APPENDIX G-1

Compiled peer review information.

Subject: SWFWMD Peer Review Information

As part of an ongoing reevaluation of the minimum flows currently established for the Lower Peace River, Southwest Florida Water Management District staff have developed new, proposed minimum flows for the Lower Peace River and proposed minimum flows for Lower Shell Creek. As you know or will learn during the peer review process, minimum flow sets a limit beyond which further water withdrawals would be significantly harmful to the water resources or ecology of the area.

Figure 3-3. Box and whisker plots of a) surface and b) bottom salinity measured at selected HBMP fixed-station locations in the Lower Peace River and near the river mouth (see Figure 3-2) between 1976 and 2016 (reproduced from Janicki Environmental, Inc. 2017).

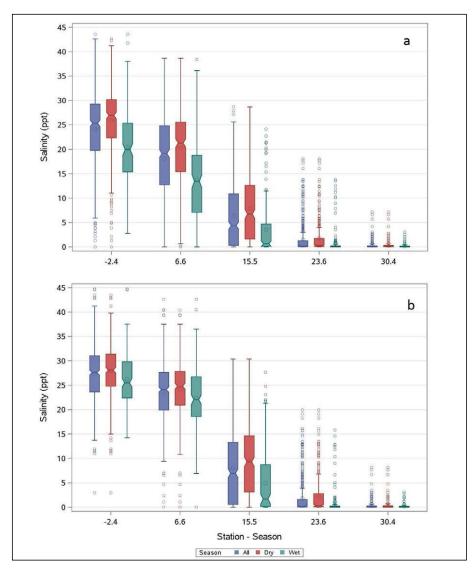
- Figure 3-3. Might it be better not to lump all the data from 1976 through 2016 exclusively, but show box and whiskers for smaller time periods (by decade?) as well, so the reader can look for trends? DO data (3.3.1.2) also lumped from 1976 to 2016 when shown.

• Figure 3-3. Might it be better not to lump all the data from 1976 through 2016 exclusively, but show box and whiskers for smaller time periods (by decade?) as well, so the reader can look for trends? DO data (3.3.1.2) also lumped from 1976 to 2016 when shown.

The PRP felt that some of the figures in the draft MFL were not overly useful, or could benefit from restructuring. For example, Figure 3-3 shows the variability in levels of salinity at various locations in the LPR. However, the analyses were conducted on 40 years of data, and variability could be due to seasonal variability, inter-annual variability, or some combination of both. Figure 3-3 is not entirely clear, as to what it is meant to convey to the reader. Suggestions were raised as to how the data could be displayed to address these concerns.

The PRP felt that some of the figures in the draft MFL were not overly useful, or could benefit from restructuring. For example, Figure 3-3 shows the variability in levels of salinity at various locations in the LPR. However, the analyses were conducted on 40 years of data, and variability could be due to seasonal variability, inter-annual variability,

or some combination of both. Figure 3-3 is not entirely clear, as to what it is meant to convey to the reader. Suggestions were raised as to how the data could be displayed to address these concerns.
